ORDINANCE NO. 3932

AN ORDINANCE OF THE CITY COUNCIL OF THE CITY OF CHANDLER, ARIZONA, AMENDING SECTION 43-5.1 OF CHAPTER 43 OF CHANDLER CITY CODE; RELATING TO THE CITY OF CHANDLER STANDARD DETAILS AND SPECIFICATIONS.

SUBJECT: May 2008 Amendment to the Engineering Standard Details and Specifications (2007 Edition)

C-404

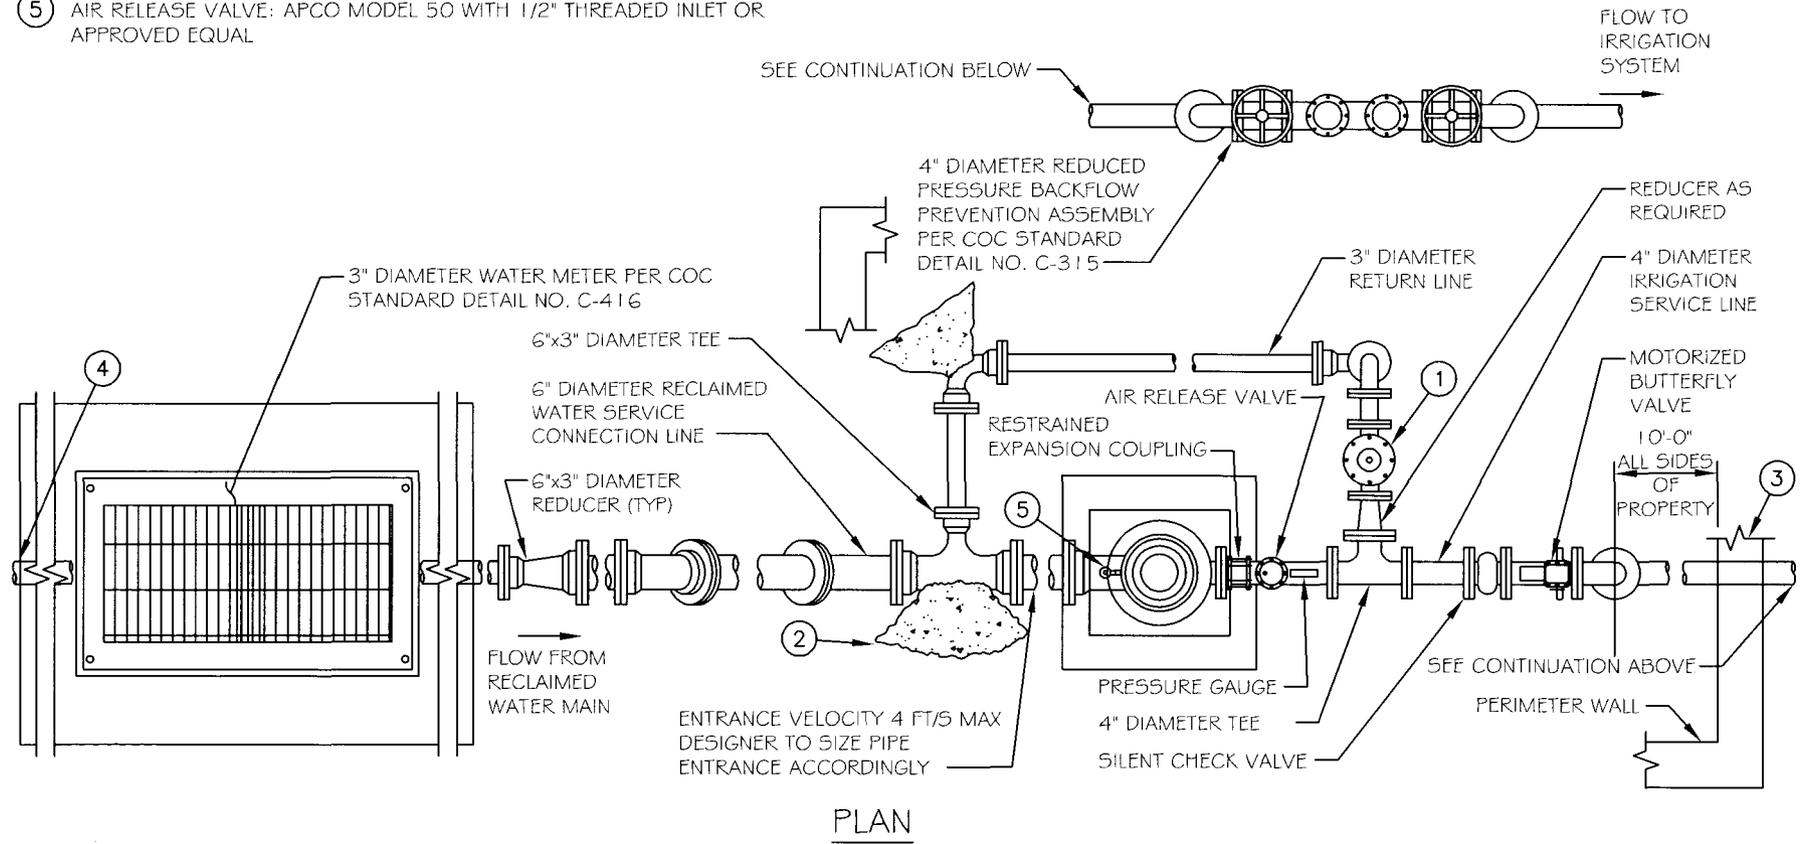
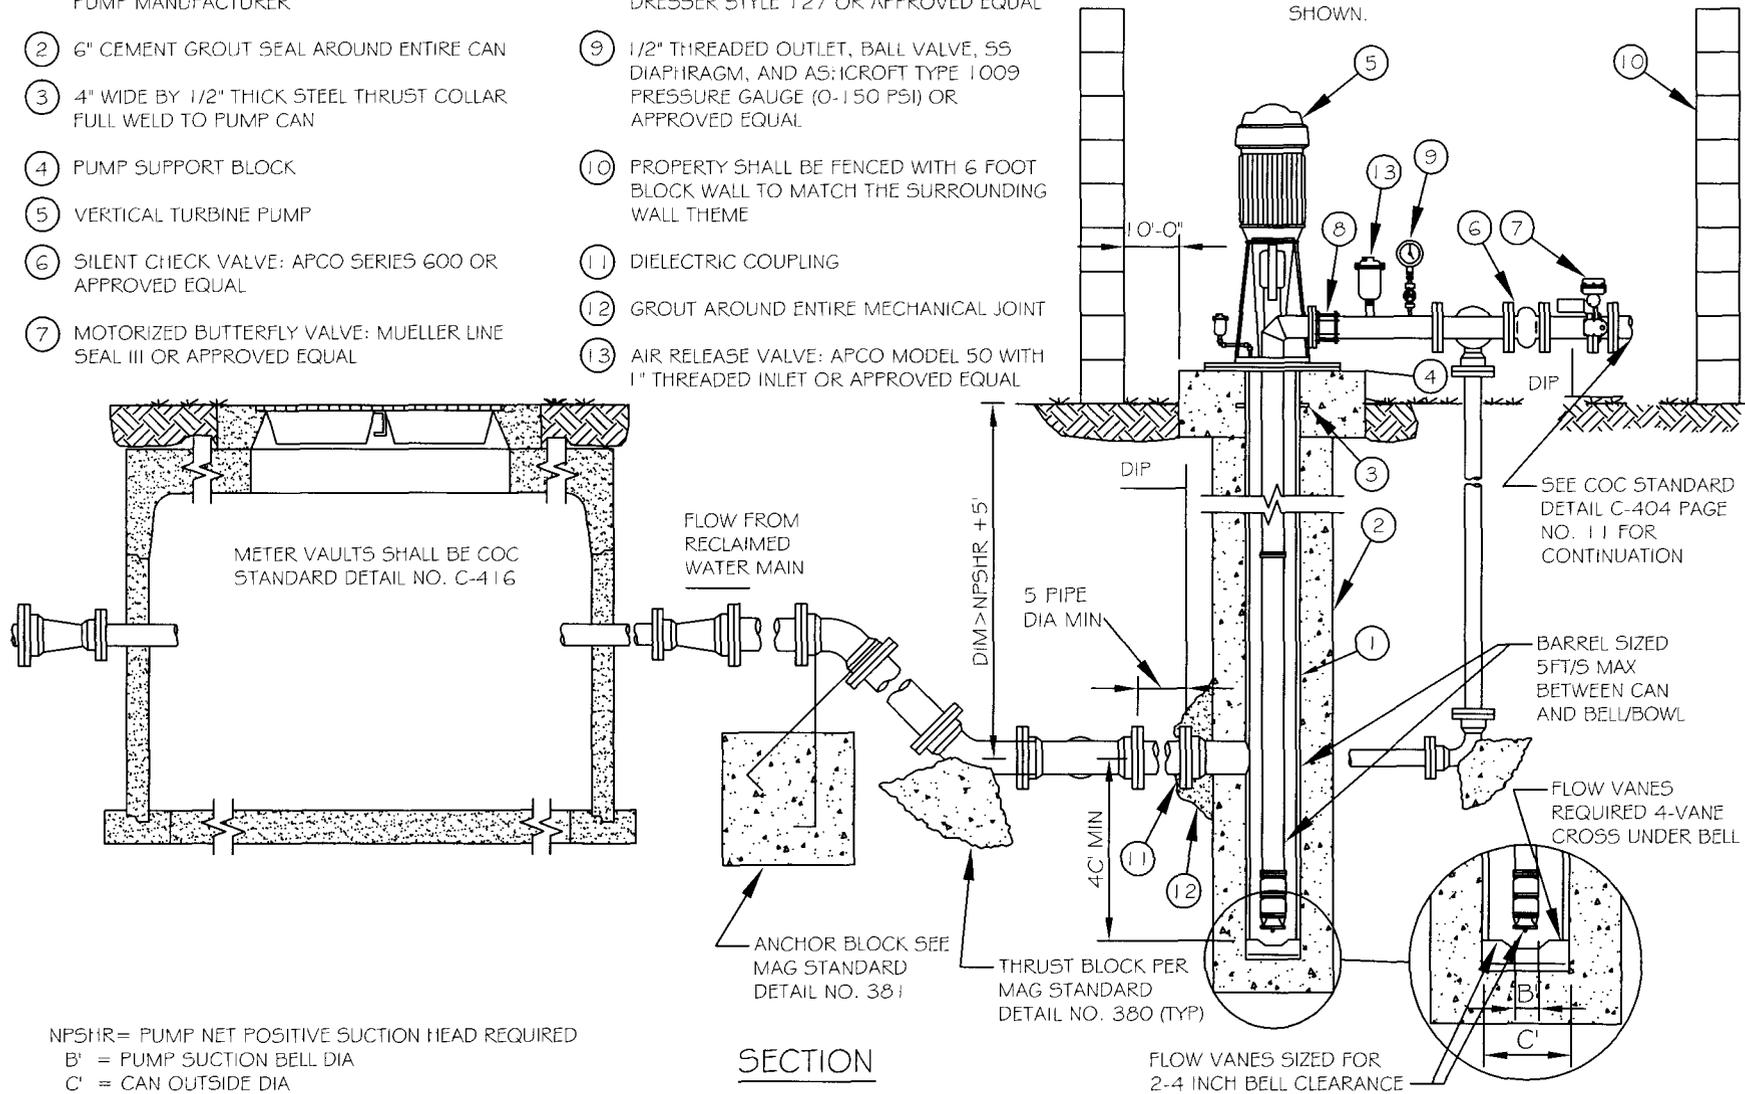
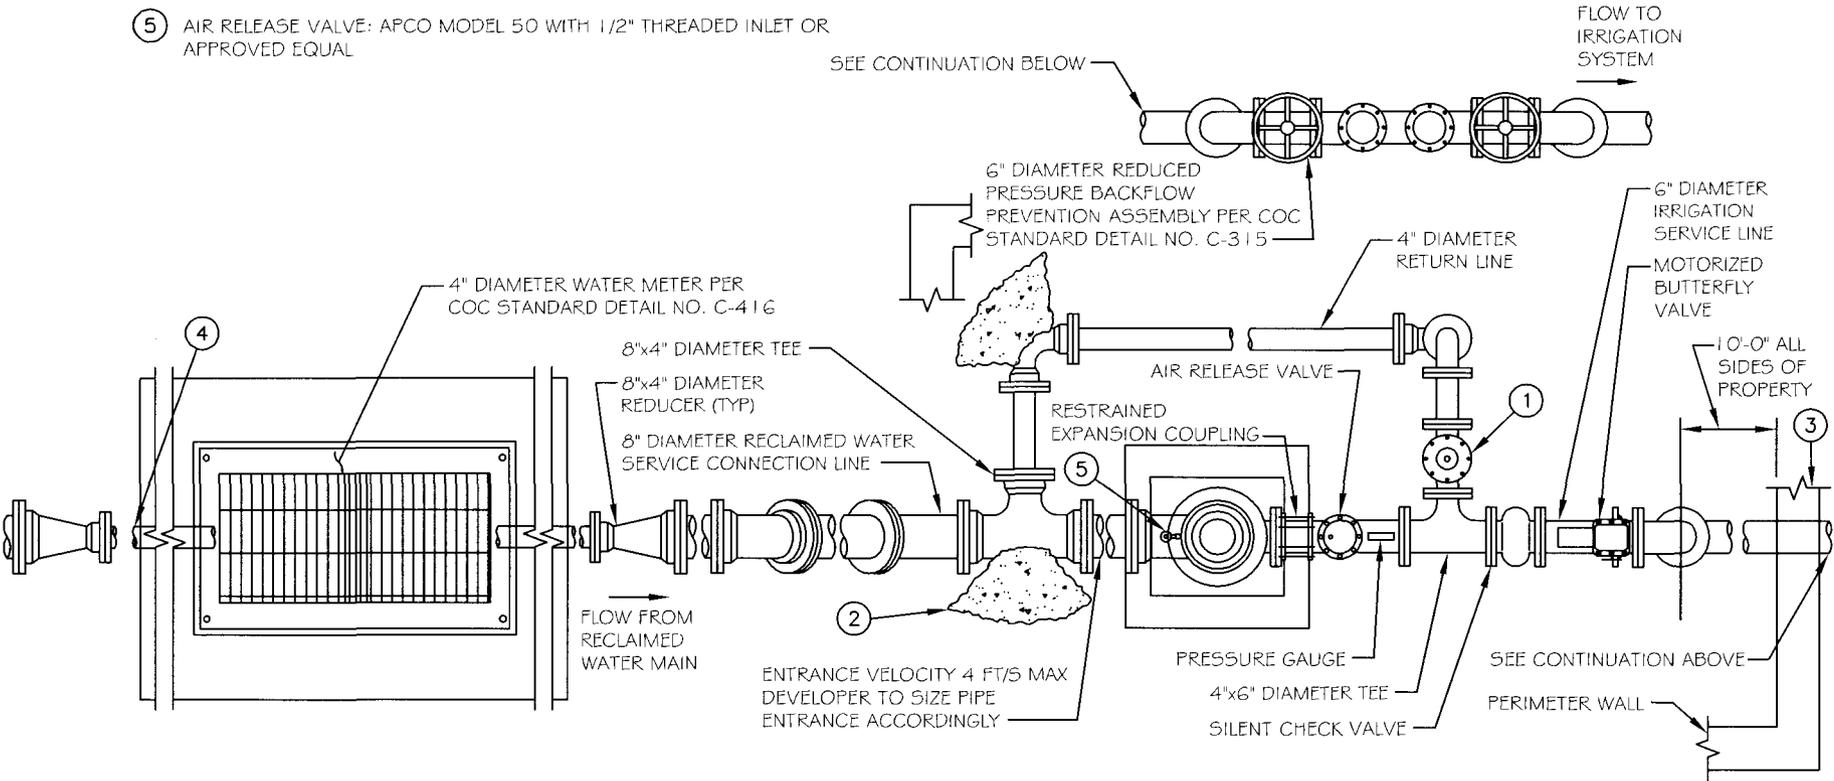
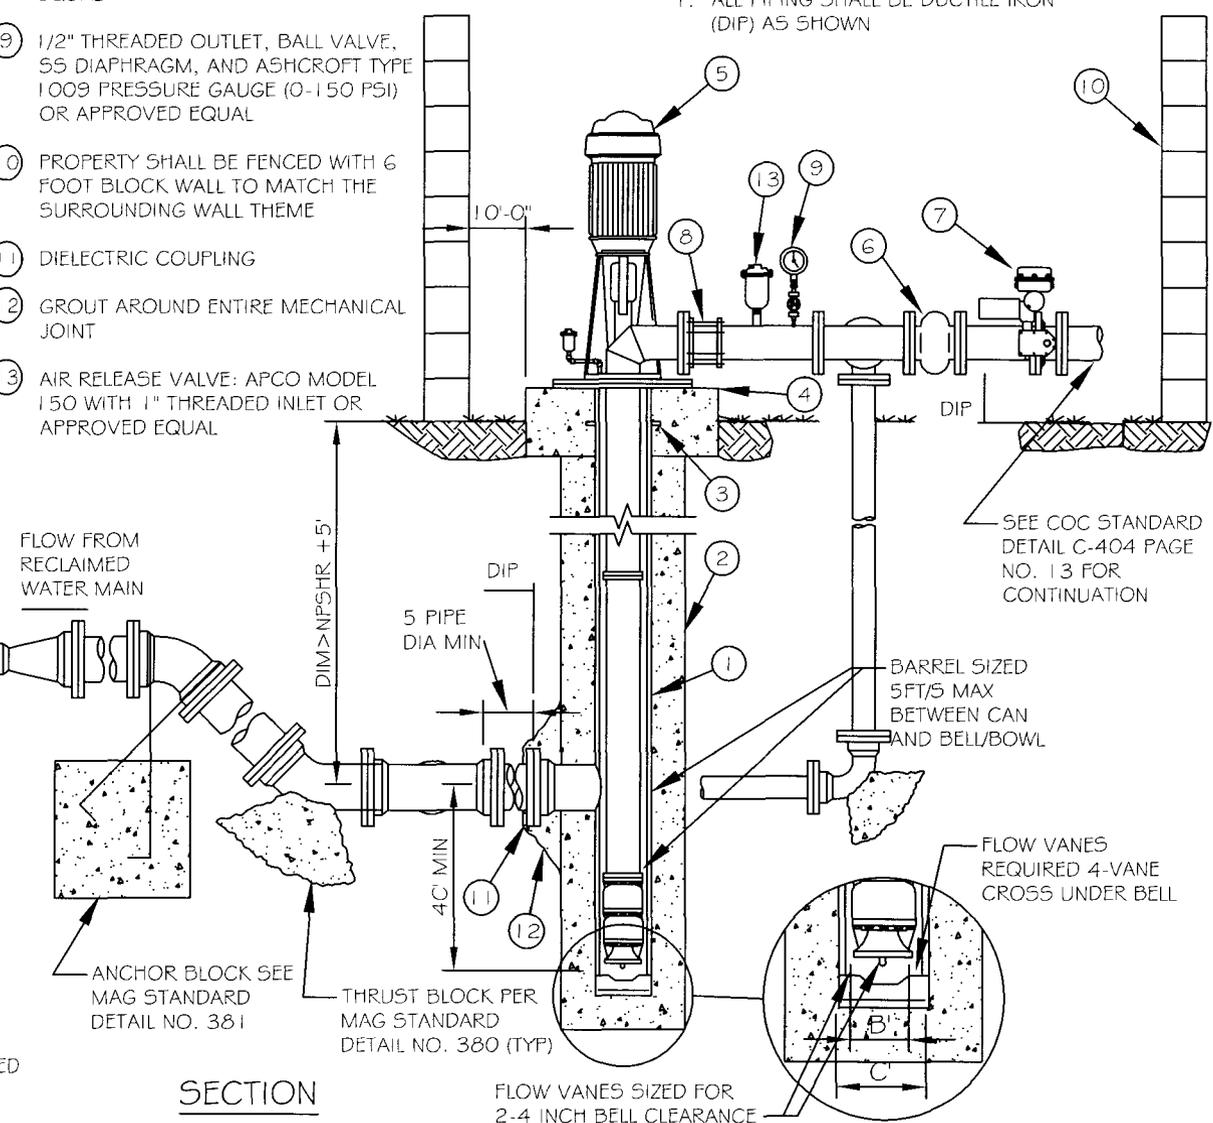
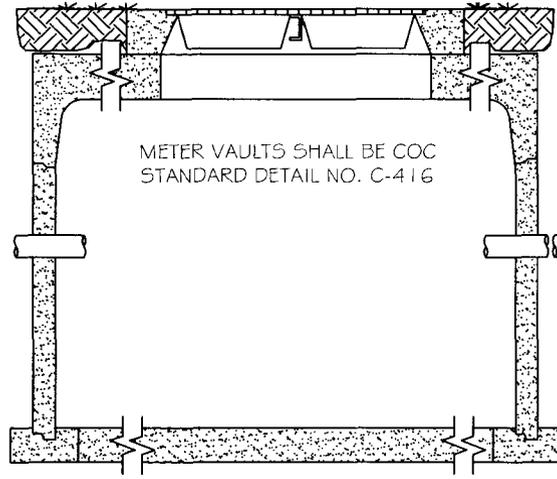
- Detail C-404 (PG 1-12) – revisions and additional standard details needed for reclaimed water services to accommodate various meter sizes and flow requirements.

DETAIL NO. C-416 NTS	 CITY OF CHANDLER STANDARD DETAIL	3" AND 4" RECLAIMED WATER METER VAULT	APPROVED: _____ CITY ENGINEER DATE: _____	DETAIL NO. C-416 NTS
-----------------------------------	---	---	---	-----------------------------------

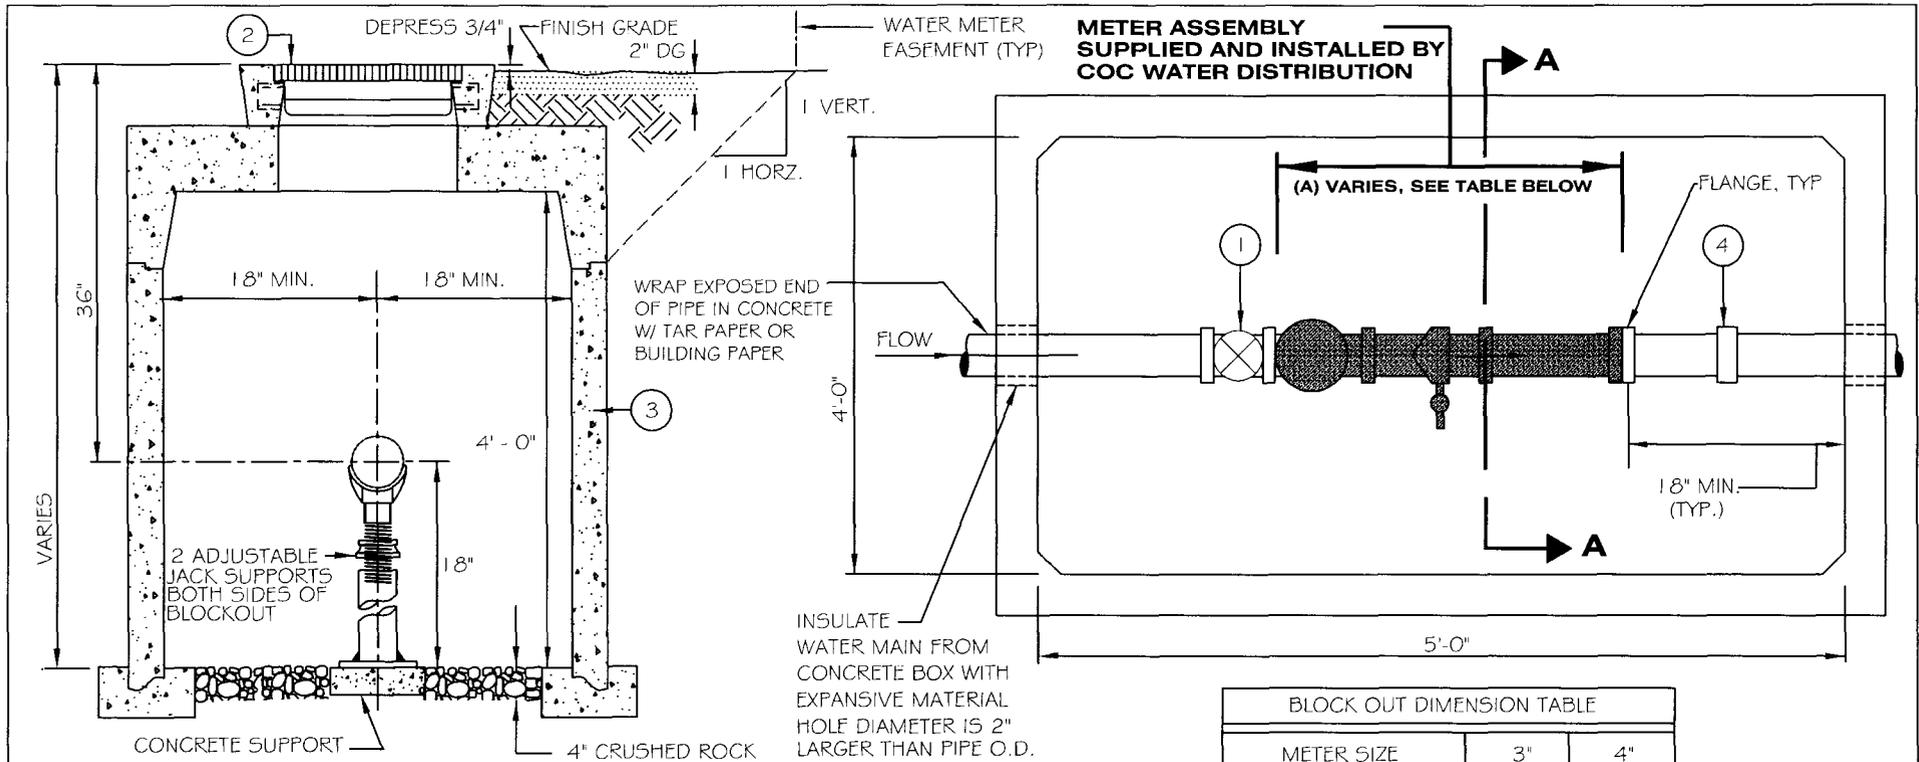
- Detail C-416 – New detail for 3" and 4" reclaimed water meter vault. Water Distribution to supply and install similar to C-316.
